**ZONING CHANGE REVIEW SHEET**

**CASE:** C814-2012-0160  
211 South Lamar PUD

**ADDRESS:** 211 South Lamar Boulevard

ENV. TREE  
PUD EXHIBIT

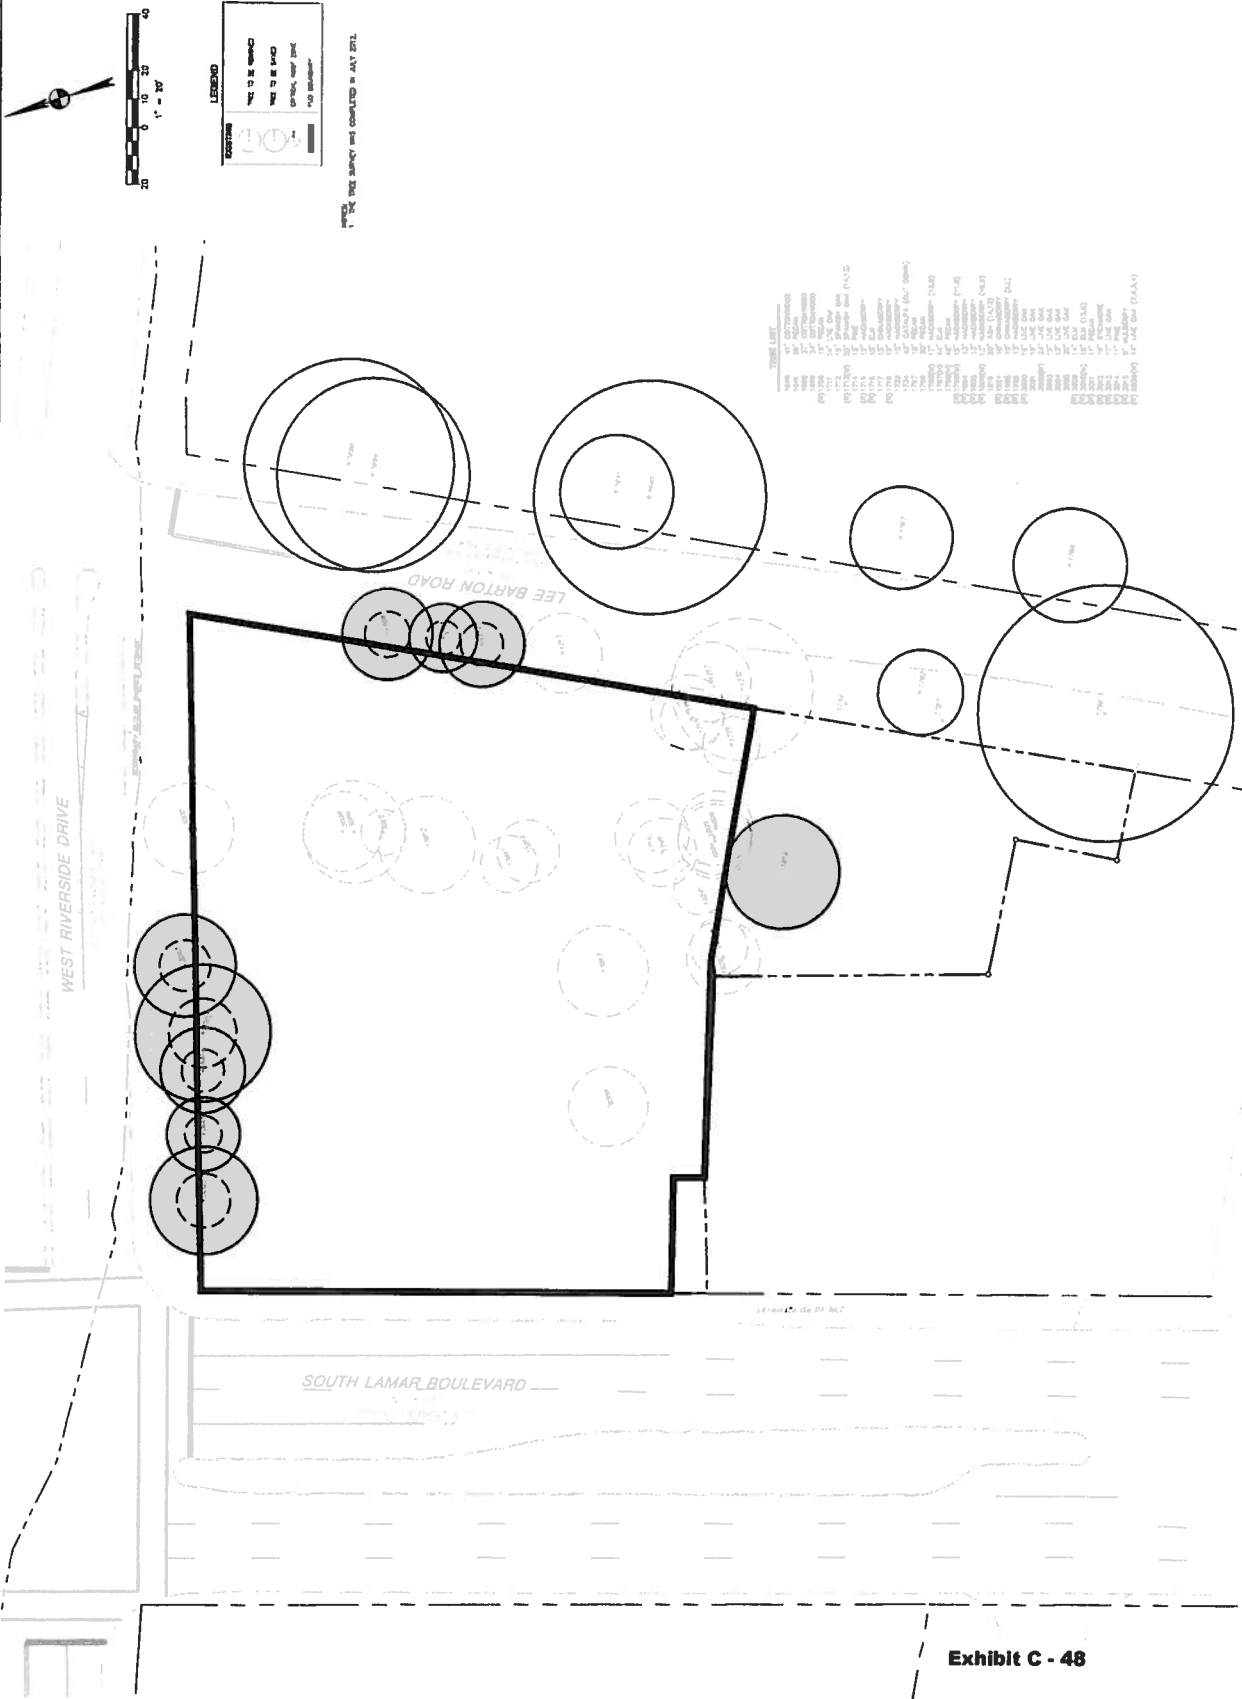
**UPDATE #1 Note # 32 addresses the tree preservation criteria required to preserve trees in the PUD. The Env. Tree PUD Exhibit, sheet 4, shows tree #1709 to be removed in the list when it is supposed to remain, and it shows tree 1732 with a 50 ft CRZ instead of a 30 ft CRZ as stated in the tree survey list. Please correct these inconsistencies. This comment can be cleared informally.**
